**RE: Traffic Supplement
Proposed Dunkin' Restaurant
Route 206 & Georgetown-Franklin
Turnpike (CR 518)
Township of Montgomery
Somerset County, NJ
DT# 3334-99-001TE**

Dynamic Traffic has prepared the following to supplement our October 9, 2020 Traffic Impact Assessment for the above referenced project as well as to provide responses to the Traffic Impact Study related comments in the September 12, 2021 review letter from the Board's Traffic Consultant, Bright View Engineering. Specifically, an updated analysis was prepared for the most critical weekday morning peak hour. Dunkin' restaurants generate their peak traffic demand simultaneous with the peak roadway demand during this time period. During the weekday evening peak hour, the Dunkin' traffic generation is less than half of that of the morning. On Saturdays, the peak time period for a Dunkin' restaurant occurs in the morning while the roadway network peak demand occurs during the midday and early afternoon. Therefore, from a traffic impact perspective, the weekday morning peak hour is the most critical.

Table II
Internal Intersection Volume Routing

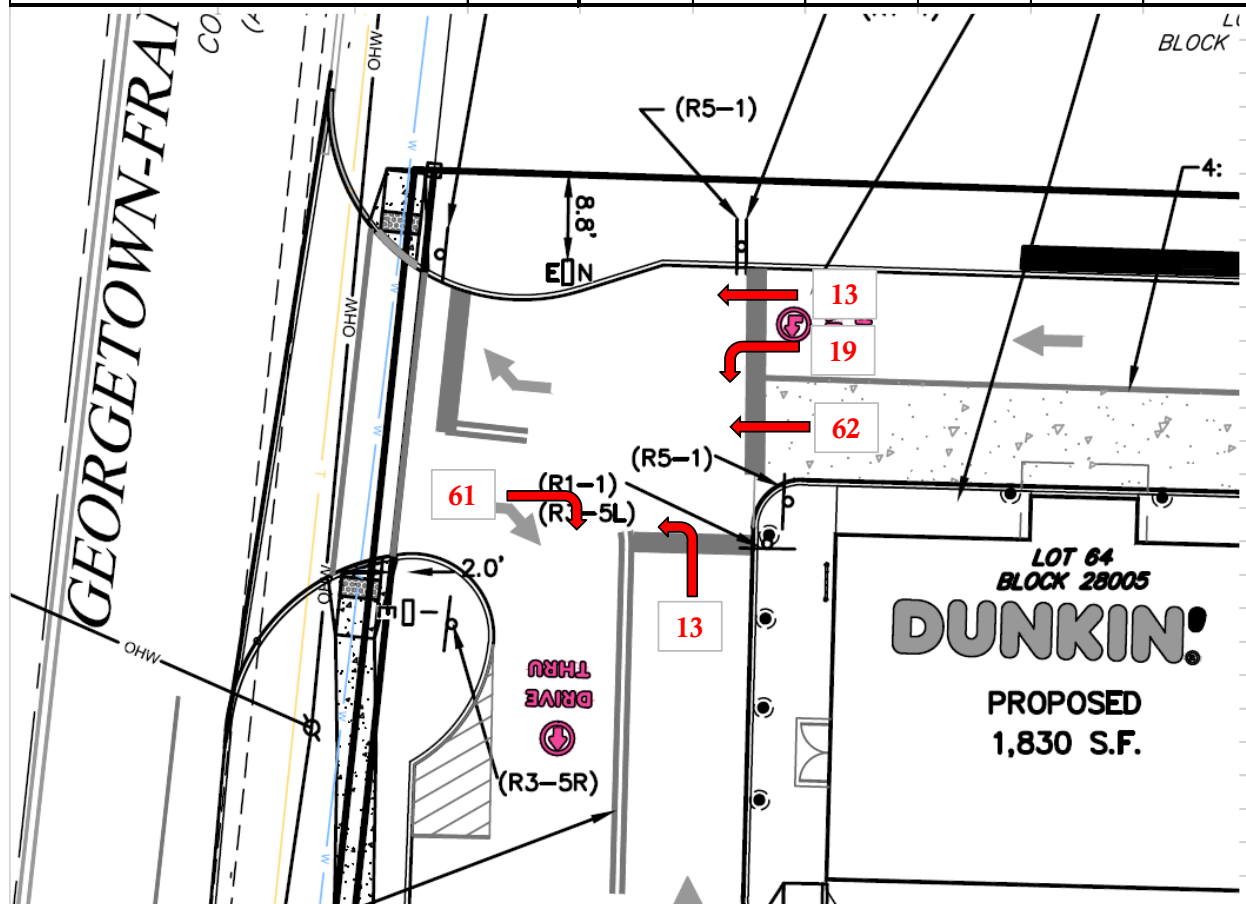
20. Testimony should be provided regarding the anticipated operation of the area on site where the drive through exit, by-pass lane exit, and CR 518 entrance converge. Of particular concern of this office is what interactions at this location could causing queuing onto CR 518 or otherwise hamper on site circulation.

- a. **An assessment was made of the traffic volumes traversing the internal intersection as tabulated and shown graphically below. Pursuant to transactional data sourced from 27 Dunkin' restaurants, provided to our office by another operator, and, based on the experience of the Applicant, approximately 70% of the site generated traffic utilizes the drive-thru system with 30% parking and walking into the restaurant. This was the basis of the internal routing of the site generated traffic as shown in Table II.**

A capacity analysis was prepared with SYNCHRO using the latest Highway Capacity Manual methodology and is appended. The analysis indicates that all movements at the intersection will operate with minimal delay at Level of Service "A" during the critical weekday morning peak hour. Furthermore, the calculated 95th percentile queue lengths are calculated to be less than one (1) vehicle for all approaches. Therefore, it is anticipated that the internal intersection will operate efficiently.
